March 10, 2005

Inter-Municipality
Committee

Re: Watershed Management Planning
Ecorse Creek Watershed
General Storm Water Discharge Permit (MIG619000)

Ecorse Creek Watershed Location

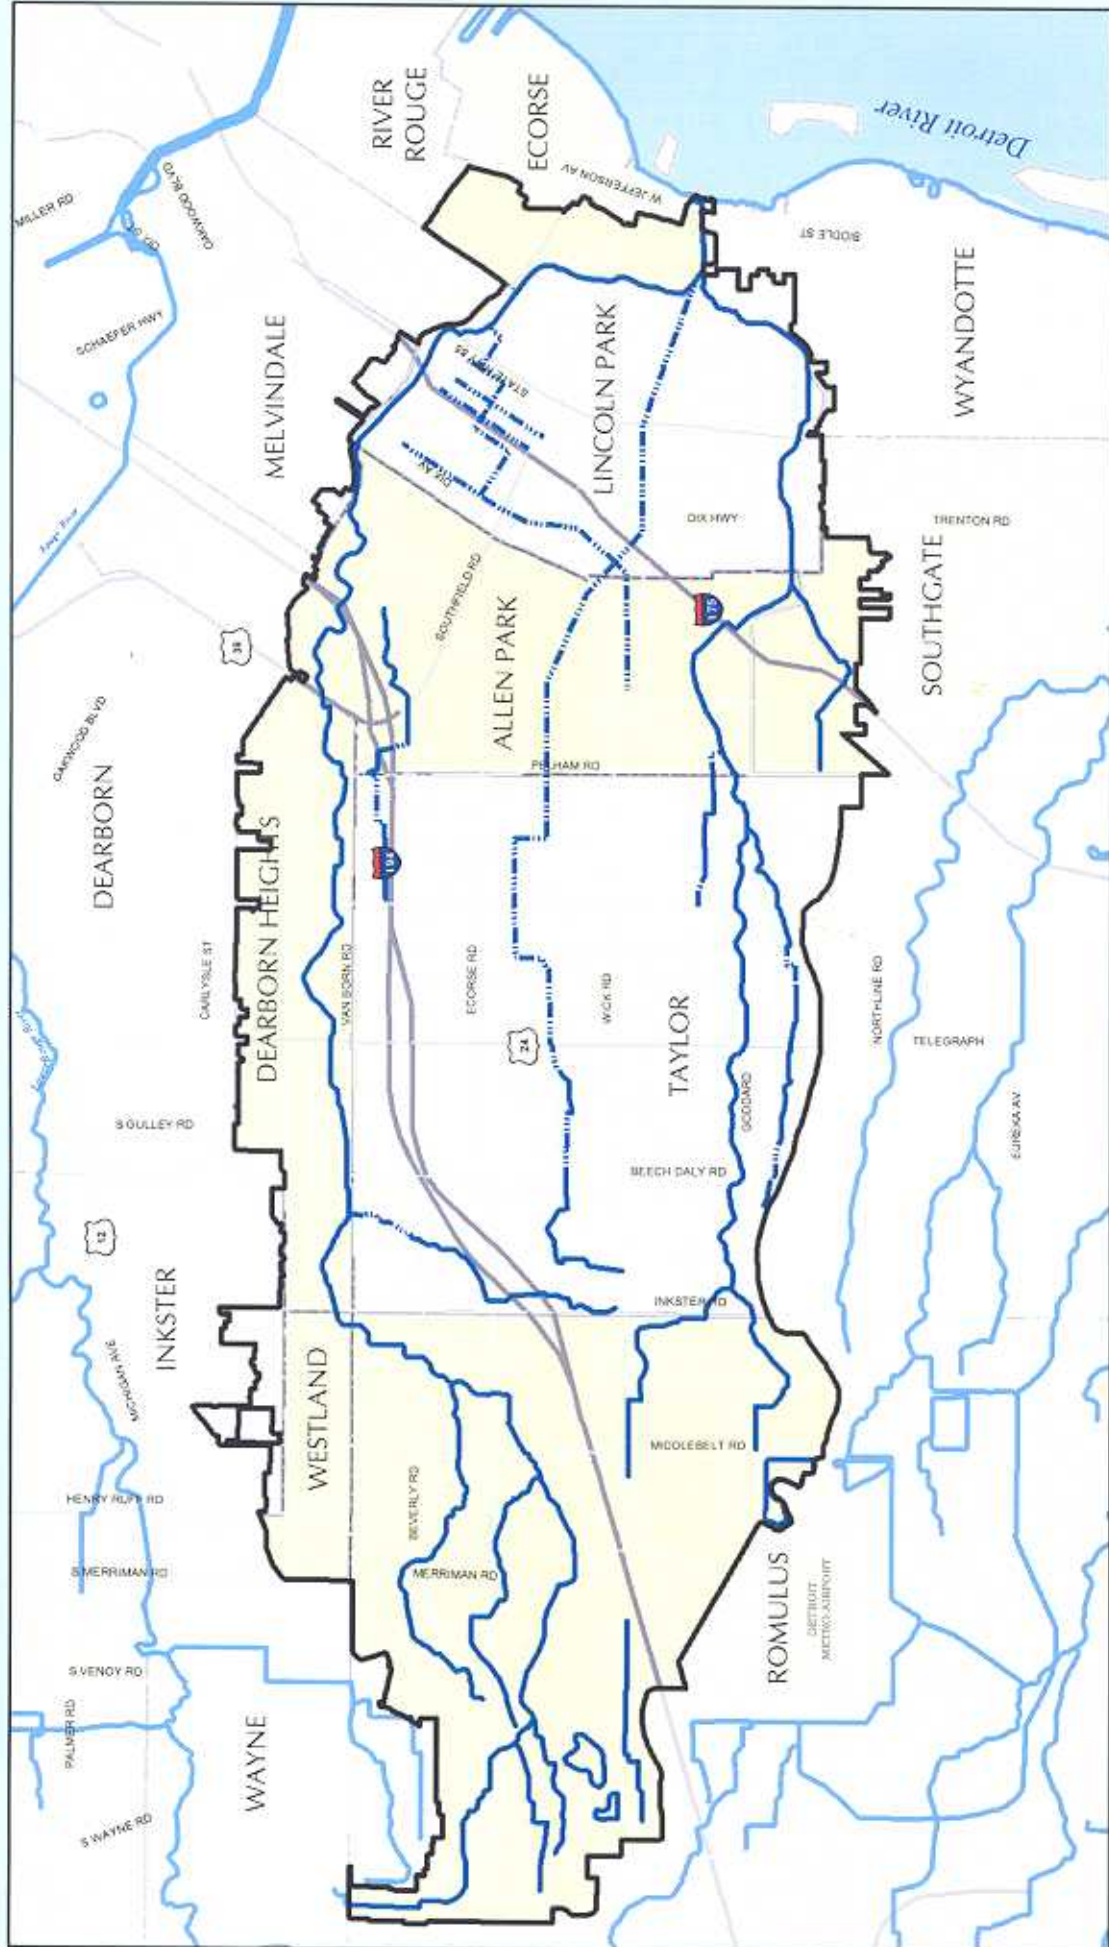
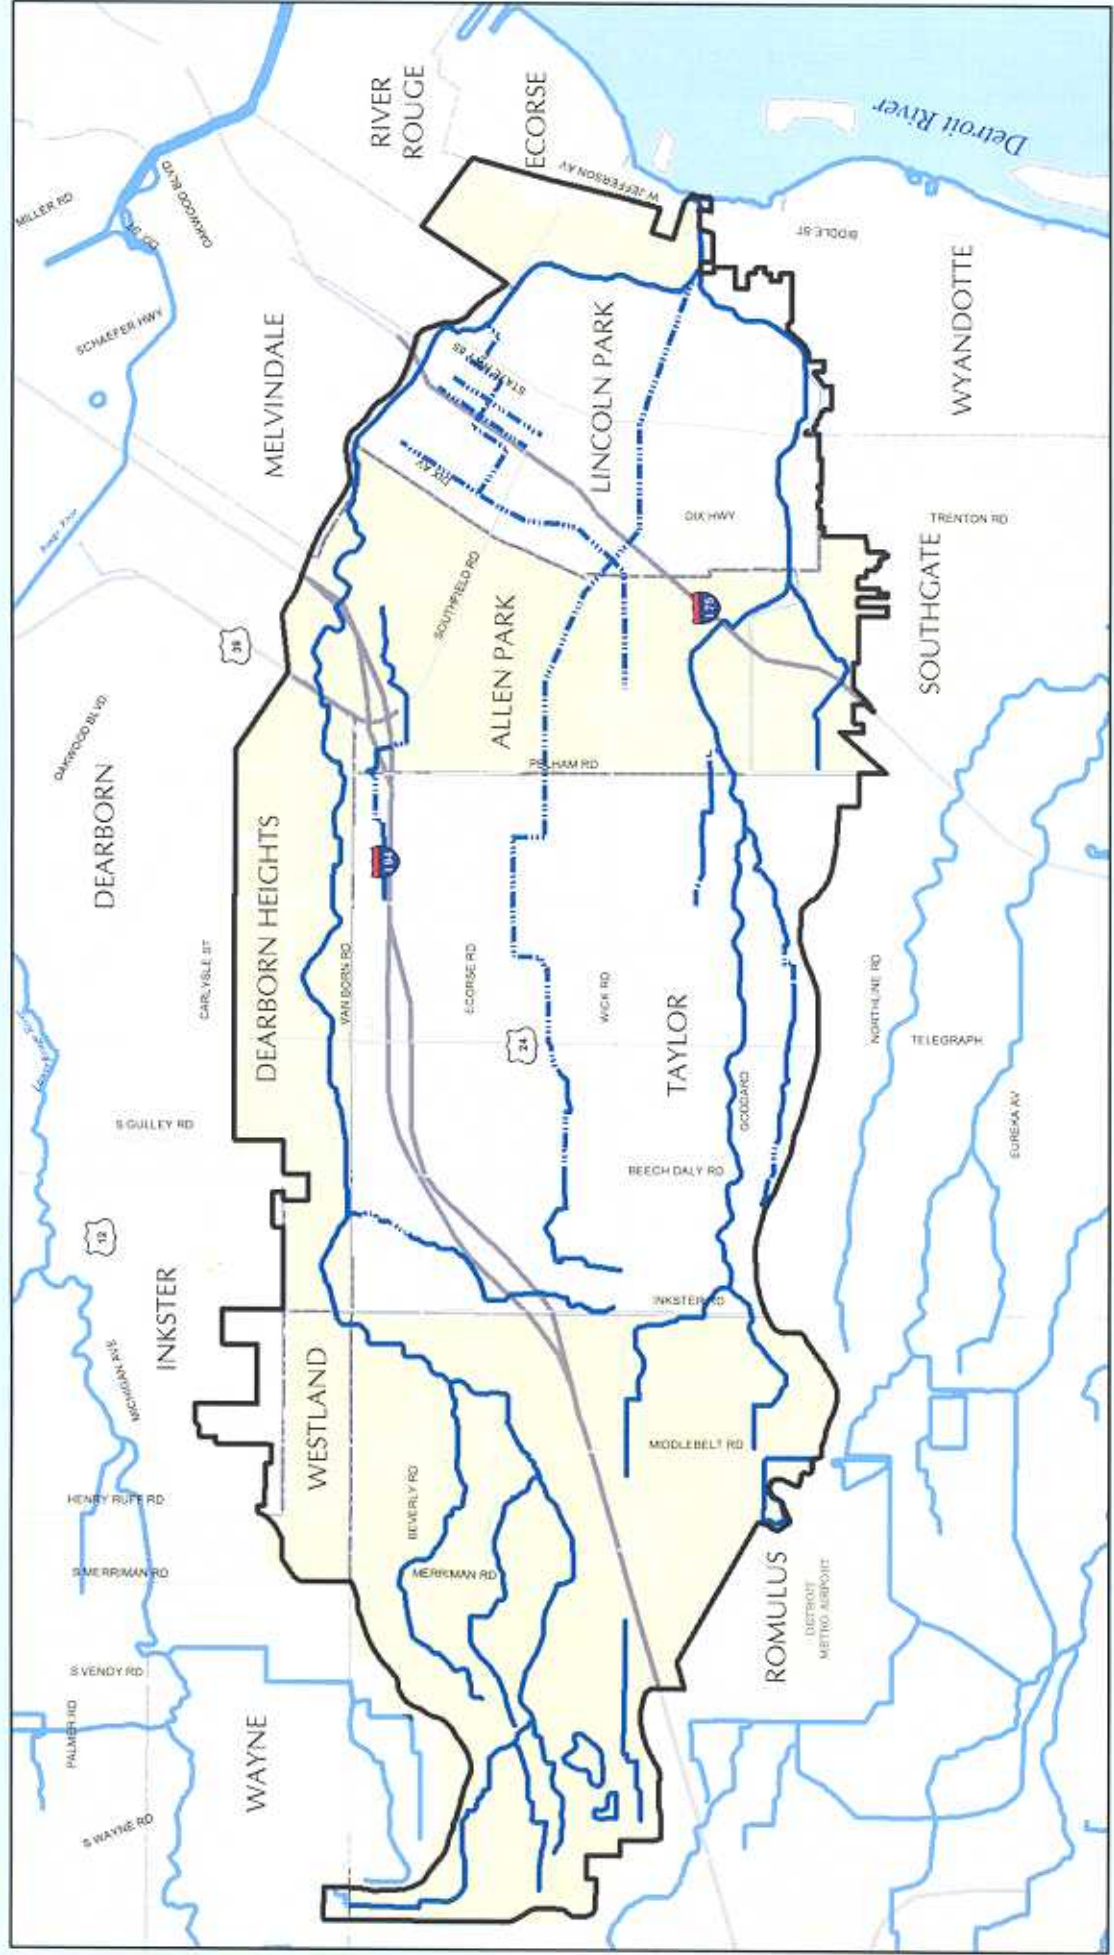
In December 2004, the ECIC approved an amended watershed boundary for the Ecorse Creek Watershed (see enclosed map). The amended watershed boundary is based upon new, field-verified information about the northern boundary of the watershed developed by a separate project being undertaken by the Wayne County Drain Commissioner’s Office. The field verification and subsequent revisions to the northern boundary of the watershed revealed differences when compared to the watershed boundary that the ECIC previously submitted to MDEQ and was using for their Watershed Management Plan development efforts. We believe that the field - verified watershed boundary is more accurate than the previously submitted version. Note that that the revised watershed boundary has the following primary differences from the previously submitted version:

- City of Wayne is no longer in the Ecorse Creek Watershed,
- City of Romulus has slightly more area in the Watershed,
- Inkster has slightly less area in the Watershed,
- Dearborn Heights has slightly less area in the Watershed,
- City of Melvindale is now in the Watershed, and
- City of Ecorse has slightly less area in the Watershed.

Overall, the revised watershed boundary results in 133 additional acres within the Ecorse Creek watershed. At their December 6, 2004 meeting, the ECIC agreed for the sake of consistency, continuity and accuracy, that the new, field verified, northern watershed boundary be adopted and utilized in the development of the Watershed Management Plan.
